<b>Subject:</b>	Potential cracks in the left and right engine bearer and the attachment of the fuel pump
<b>Applicability:</b>	ASW 28-18E TCDS EASA A.034, all serial numbers
<b>Urgency:</b>	A) Within 30 days after the effective date of the corresponding AD If the inspection proves that the engine bearer is affected: B) Within 30 days after the effective date of the corresponding AD C, D) Within 30 days after the effective date of the corresponding AD, provided the conditions described in the actions are fulfilled E) Within 10 months after the effective date of the corresponding AD F, G) After completion of actions C and D respectively E
<b>Reason:</b>	Cracks appeared in the horizontal tube of the left or right engine bearer (Fig. 1). Not affected are engine bearers of the following two kind: <ul style="list-style-type: none"><li>• Either those, which are already reinforced and were marked by a punched X (Fig 2).</li><li>• As well as those, which were installed due to TN 10, action A (drawing number 850.67.0110).</li></ul>

**Fig 2:** Engine bearer marked with a punched X (arrow)

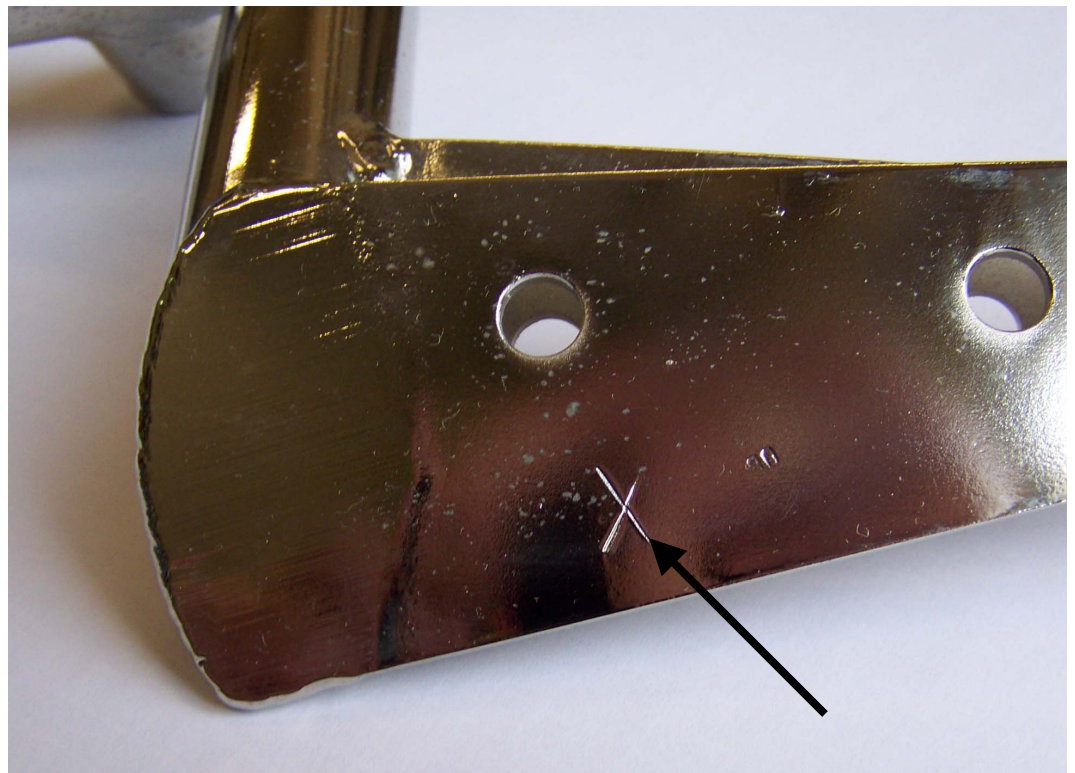
<b>Action:</b>	A) It has to be checked, if the engine bearer is affected. No further action is necessary, <ul style="list-style-type: none"><li>• if the engine bearers are marked with a punched X. (Fig. 2)</li></ul> or <ul style="list-style-type: none"><li>• if TN 10, action A, has been implemented. (Fig. 3)</li></ul> In all other cases action B and E, and, where necessary, C and D are required.B) B.1) The following manual pages have to be exchanged against new ones with the revision status "TN 15 / 01.05.14": Flight Manual: Pages 4.10 and 4.11 The exchange of manual pages must be entered on the page „Record of Revisions“ and in the „List of effective pages“. B.2) The right engine bearer and the left engine bearer are to be inspected visually for cracks in the area of the horizontal tube (Fig. 1, ①).  B.3) The attachment of the fuel pump (Fig. 1, ②) is to be inspected visually for cracks. If damage can be found, the part is to be replaced against a new part. C) If, during the inspection as required by paragraph B.2, any crack is detected: <ul style="list-style-type: none"><li>• before next flight, replace both (LH and RH) engine mounts (engine bearers) with serviceable parts, which are marked with a punched X. (Fig. 2)</li><li>• or before next flight install a placard "DO NOT OPERATE THE ENGINE" above the power plant instrument or on a better visible and suitable location on the instrument panel: "DO NOT OPERATE THE ENGINE". This is considered being eligible for release by the Pilot-owner pursuant to EU-VO. 2042/2003 M.A.801(b)3.</li></ul> D) If, during the inspection as required by paragraph B.3, any damage is detected: <ul style="list-style-type: none"><li>• before next flight, replace the fuel pump attachment with a serviceable part.</li><li>• or before next flight install a placard "DO NOT OPERATE THE ENGINE" above the power plant instrument or on a better visible and suitable location on the instrument panel: "DO NOT OPERATE THE ENGINE". This is considered being eligible for release by the Pilot-owner pursuant to EU-VO. 2042/2003 M.A.801(b)3.</li></ul>
